ADDENDUM NO. 1

HOLDEN
Federal Aid Project No. HIP(NGB)-003S(963)X
Bridge Replacement, H-18-004, Salisbury Street over G&W Railroad

QUESTIONS AND RESPONSES

TEMPORARY TRAFFIC SIGNAL PLANS
SHEET 01 OF 02
MAIN STREET - BAILEY ROAD

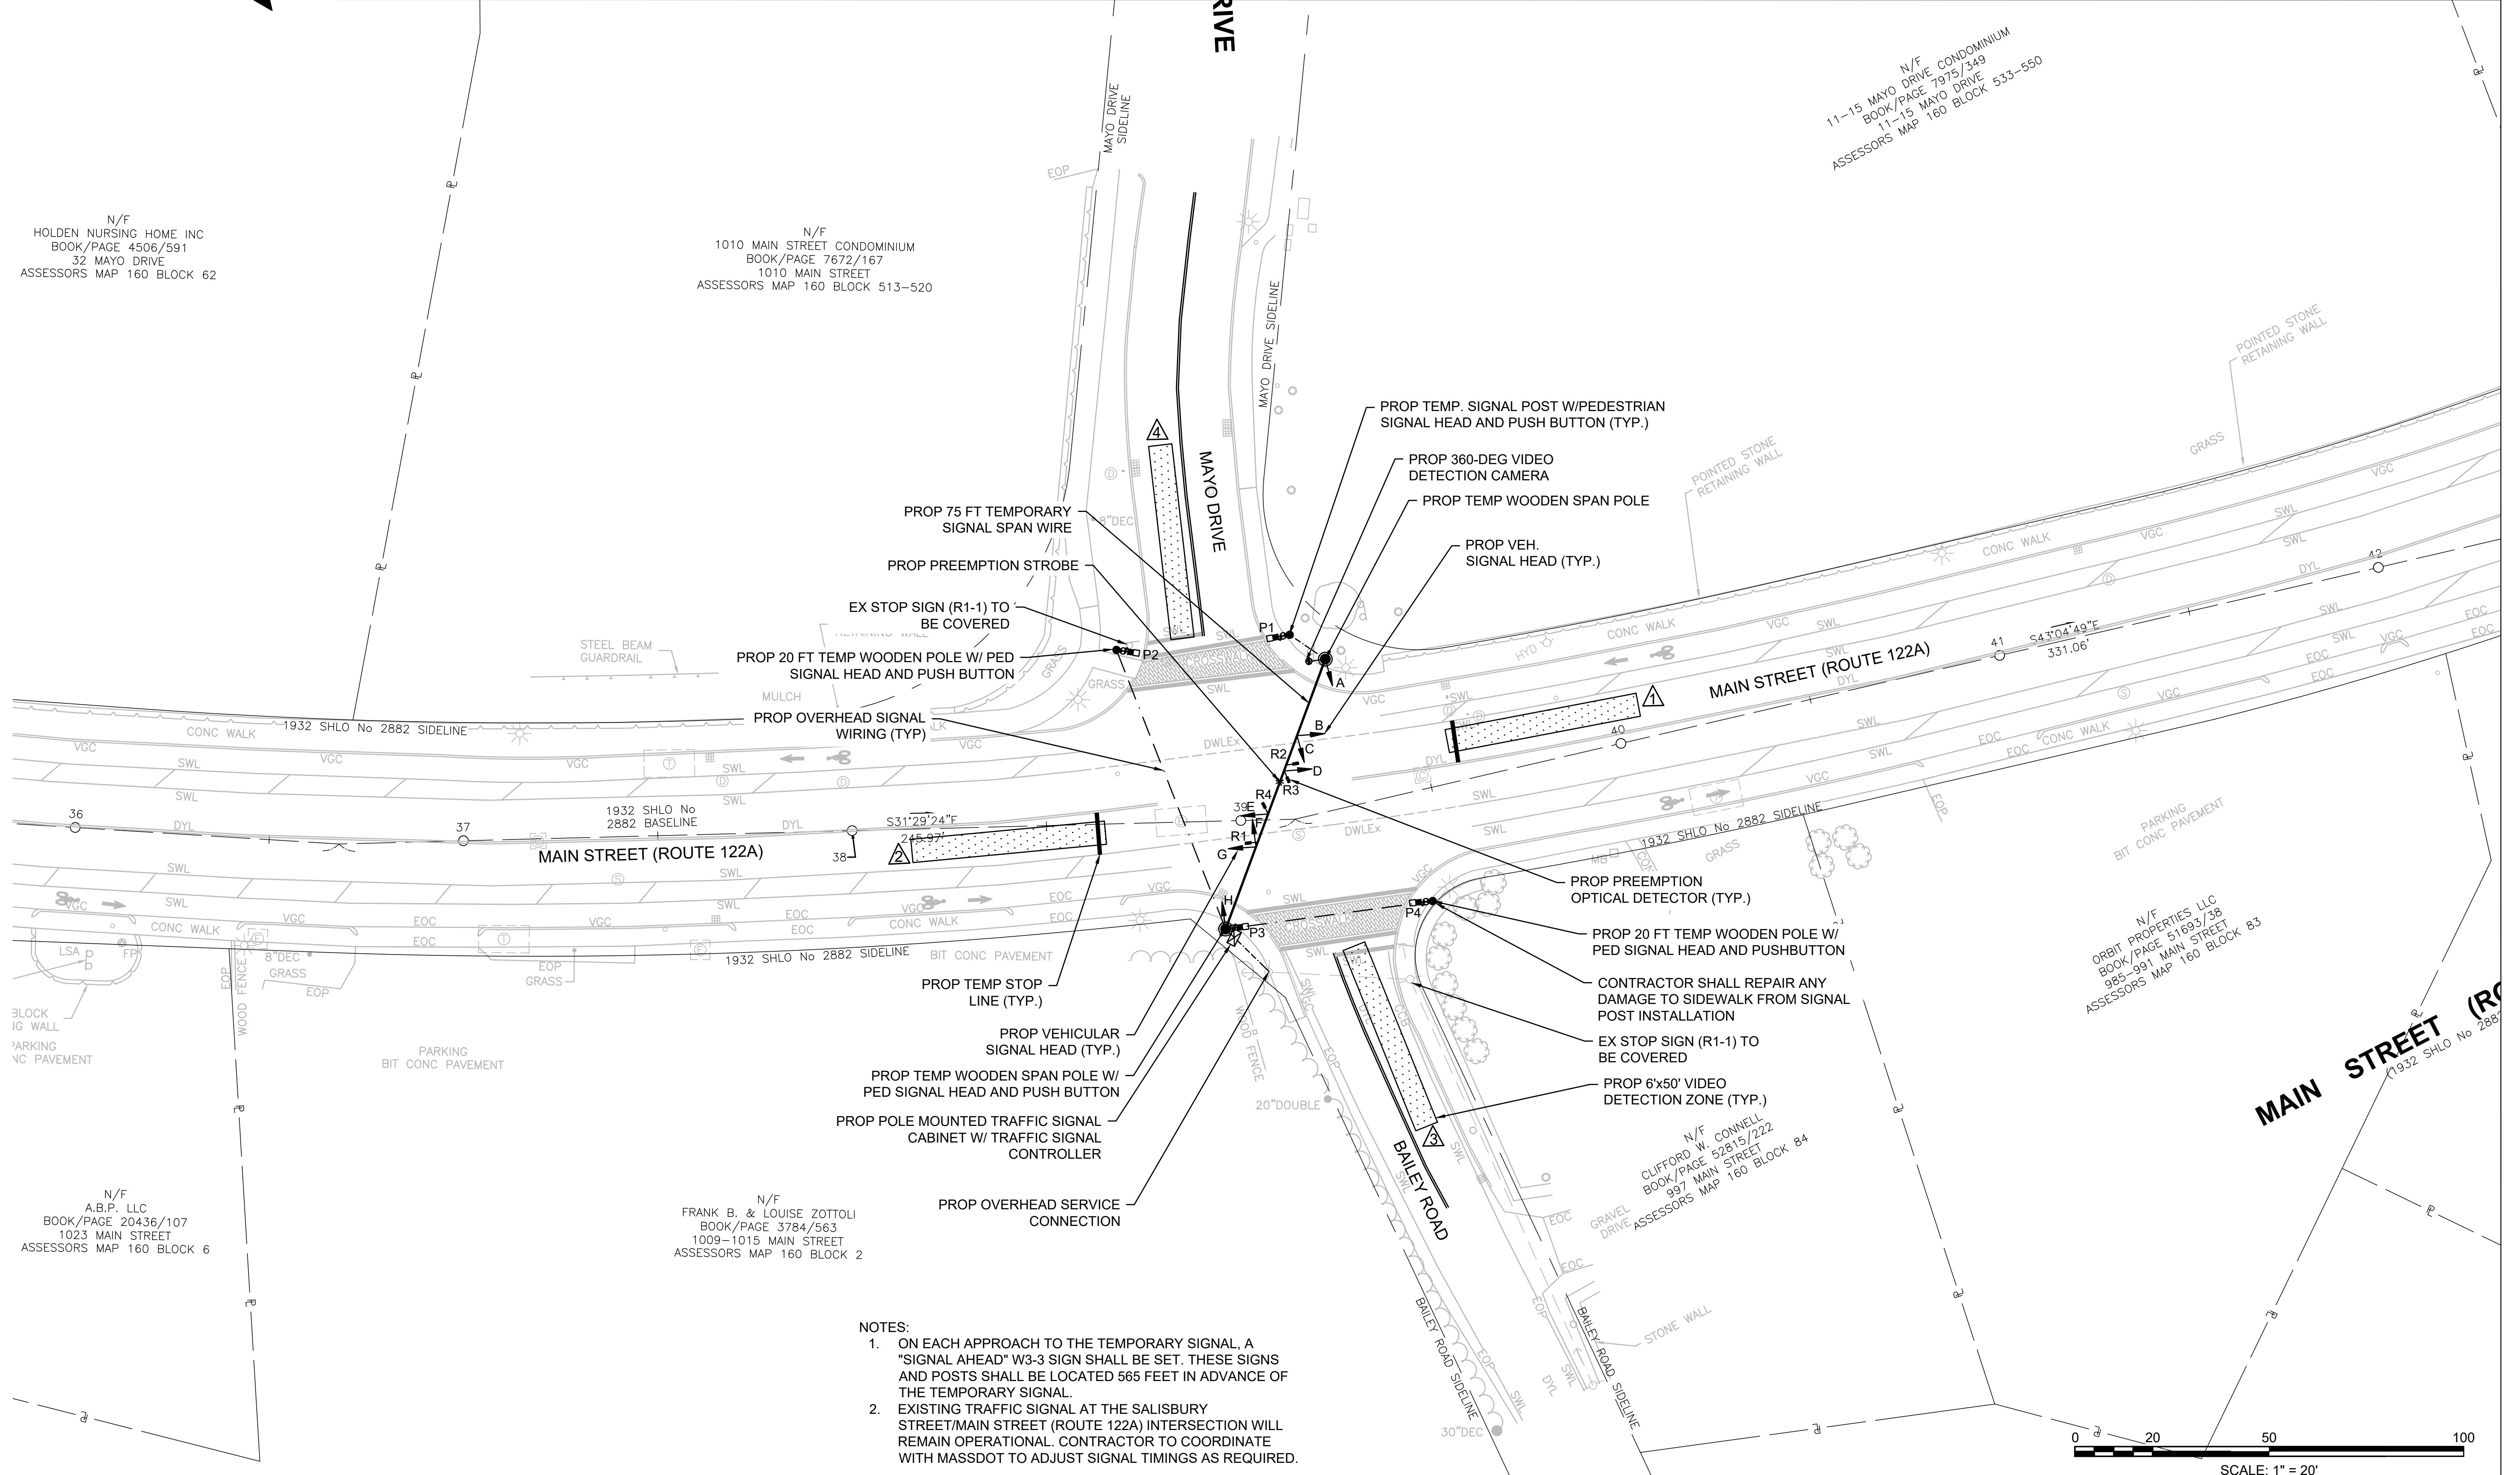
Question #1: Please provide plan sheets associated with Item 816.81.

Response #1: Refer to the new Document A00803. A Plan has been prepared along with a revised Special Provision. This item is included in the contract to account for the possibility that at Temporary Traffic Signal, when it is required by the Engineer, at the intersection of Main Street (Route 122A) at Bailey Road as shown in the Detour Plan and described in the notes on Sheets 21 and 22 of the plans.

- NOTES:
- ON EACH APPROACH TO THE TEMPORARY SIGNAL, A "SIGNAL AHEAD" W3-3 SIGN SHALL BE SET. THESE SIGNS AND POSTS SHALL BE LOCATED 565 FEET IN ADVANCE OF THE TEMPORARY SIGNAL.
 - EXISTING TRAFFIC SIGNAL AT THE SALISBURY STREET/MAIN STREET (ROUTE 122A) INTERSECTION WILL REMAIN OPERATIONAL. CONTRACTOR TO COORDINATE WITH MASSDOT TO ADJUST SIGNAL TIMINGS AS REQUIRED.
